EPSON PRODUCT SUPPORT BULLETIN

Date:	06/10/2009	Originator:	DS
TIB #:	PSB.2009.06.002	Authorization:	Kps
Reference:	TI 09-08j Rev. A	Total Pages:	8
Product(s):	PowerLite 735c / 737c / 745c / 755c / 765c / 835p / 1705/1715/1815/1825/7850p / 8300 with EasyMP.net option, Pro G5150/G5350 / 1725 / 1735W / 85 / 825 / 826W		
Subject:	Release of EMP NS Connection for Windows & Mac Upgrade from v2.50 to v2.51

Date:	04/20/2009	Originator:	JAM
PSB #:	PSB.2009.06.001	Authorization:	<i>Kas</i>
Reference:	TI 09-05e Rev. A/B	Total Pages:	5
Product(s):	PowerLite 735c / Cinema 500 / 737c / 745c / 755c / 765c / 830p / 835p / 1705c / 1715c / 6100i / 6110i / 7800p / 7850p / 7900NL / 8300i / 8300i with EasyMP.net module / 9300NL / 1815p / 1825 / 822p / 83c / 822+ / 83+ / G5000 / Pro G5150 / Pro G5350 / Pro G5200W / 1725 / 1735W / 400W / 410W / 84 / 85 / 825 / 826W PowerLite 61p / 81p / 82c / 821p / 1810 / 260d (Latin America) / 280d (Latin America) with TCP/IP to Serial converter		
Subject:	Release of EMP Monitor for Windows version 4.30

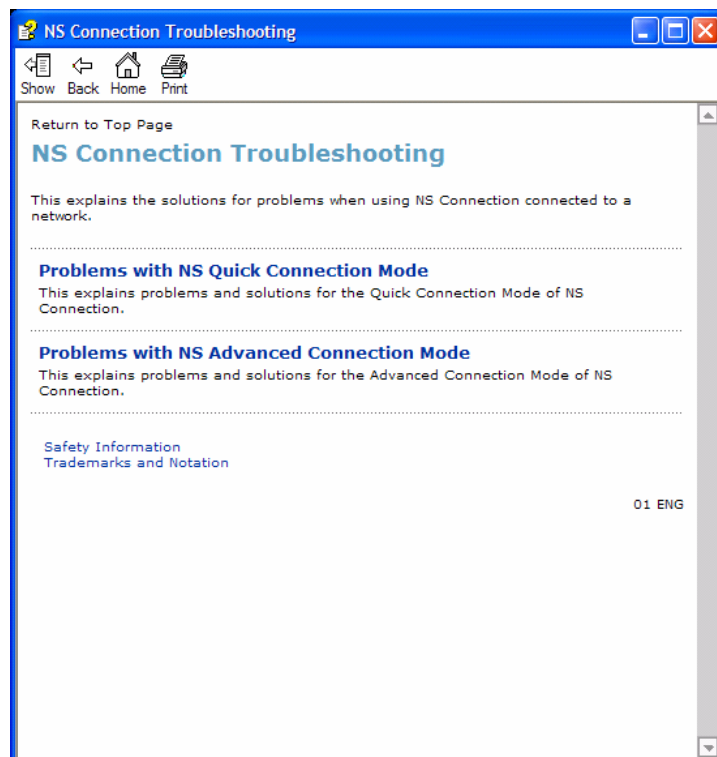
Improvements	
	■ Addition of 10 new languages: Arabic, Ukrainian, Romanian, Indonesian, Croat, Slovak, Bulgarian, Malay, Vietnamese and Hebrew. ■ Addition of troubleshooting function (Windows Only) When pressing the troubleshooting button, the corresponding troubleshooting and error number is displayed in the error message window. • When experiencing problems with NS Connect, please report to Epson the error number along with the failure information.

Also you can access troubleshooting by clicking **Start → All programs → EPSON Projector→EMP NS Connection→EMP NS Connection V2.51 Troubleshooting.**

EMP Monitor V4.30

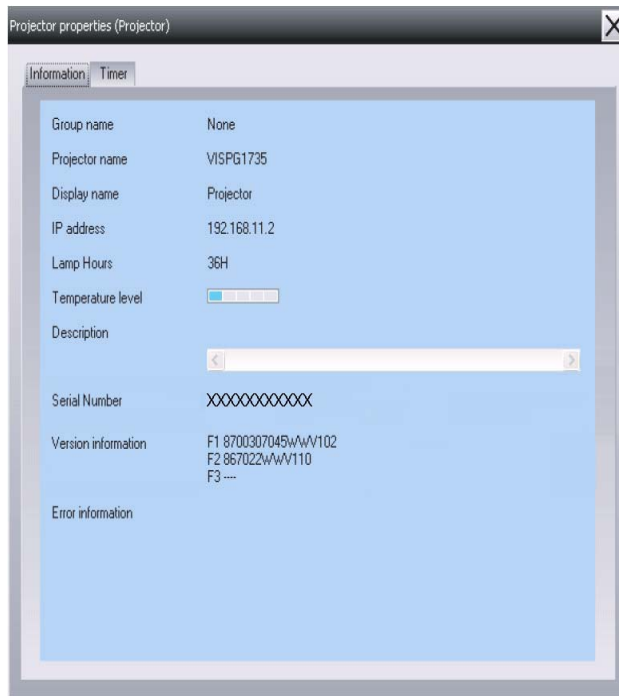
(2) Addition of Input Source (Only PowerLite 84 / 85 / 825 / 826W)
Previous version of EMP Monitor included USB Display, USB and LAN as one source: EasyMP.

The input source buttons for USB display, USB, and LAN are available as separate input sources as shown below:
